Petitions – Stop the Coundon Cycleway, and Support the Coundon Cycleway

APPENDIX A - SCHEME DETAILS

These drawings are Post-Consultation.
The notes on the plans highlight the changes
made from the consultation drawings.

Project: Air Quality Action Plan
Coundon Cycleway

Title: General Layout Sheet 16 of 17

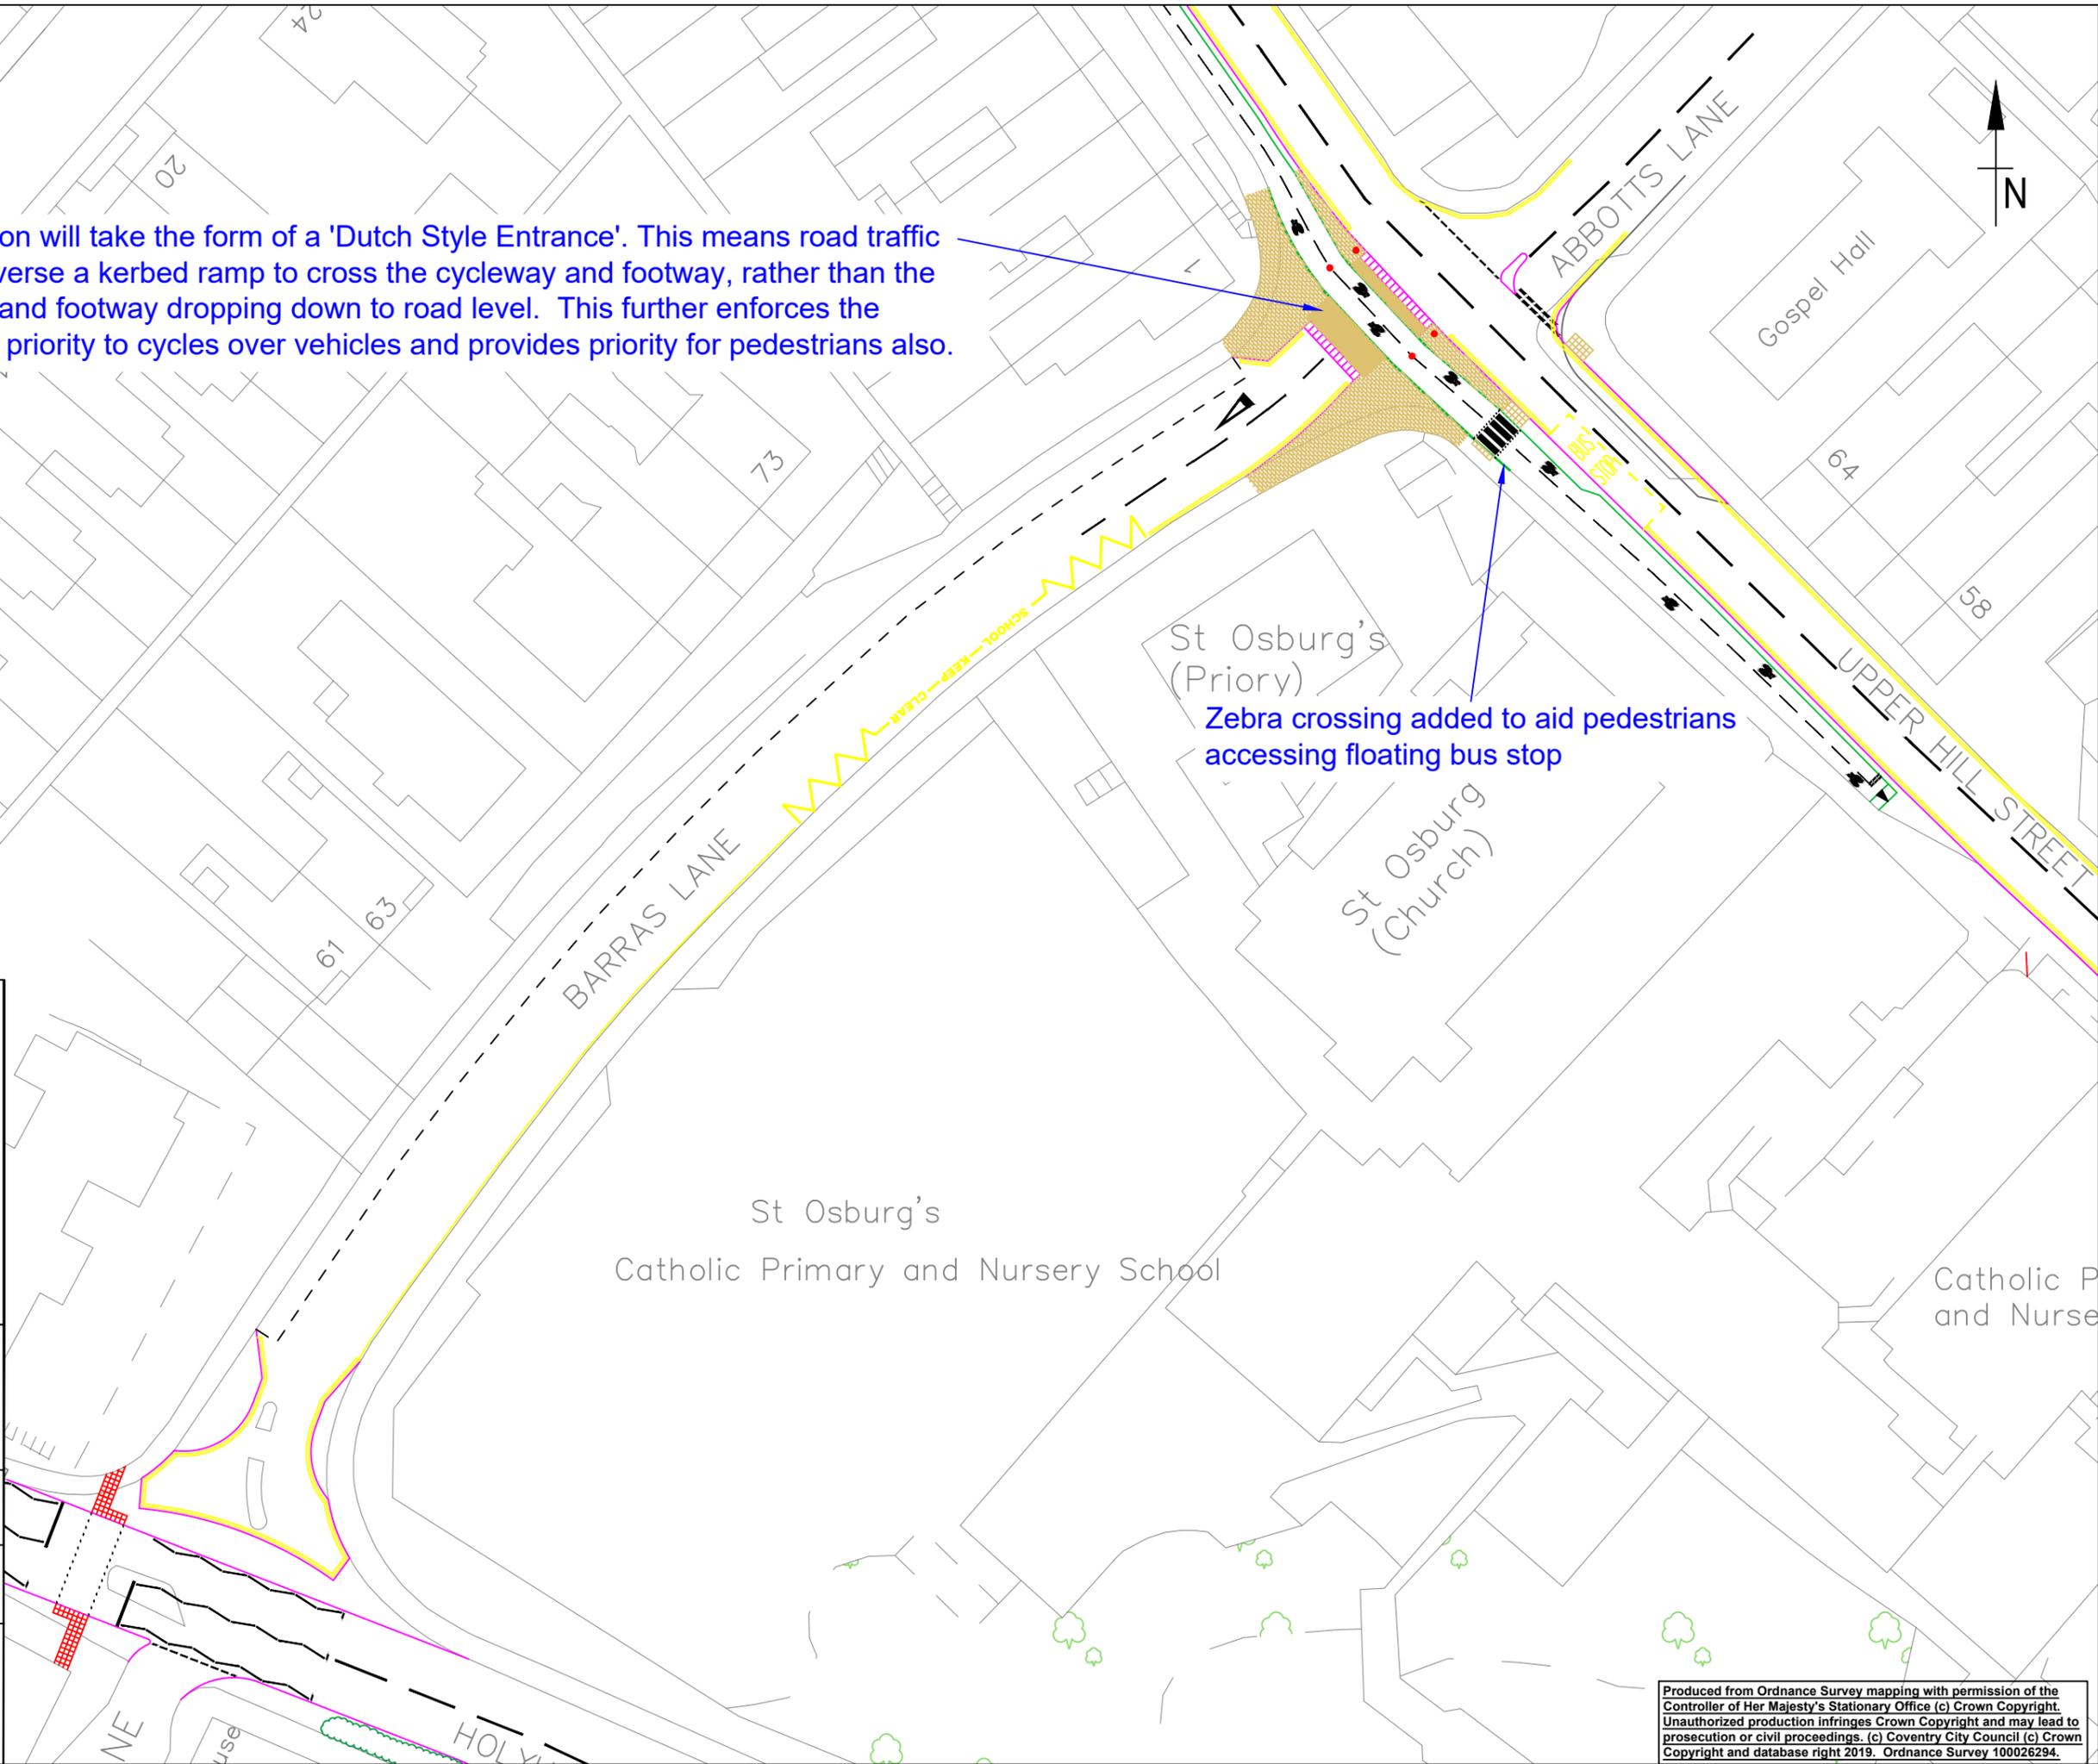
The junction will take the form of a 'Dutch Style Entrance'. This means road traffic has to traverse a kerbed ramp to cross the cycleway and footway, rather than the cycleway and footway dropping down to road level. This further enforces the change in priority to cycles over vehicles and provides priority for pedestrians also.

Zebra crossing added to aid pedestrians accessing floating bus stop
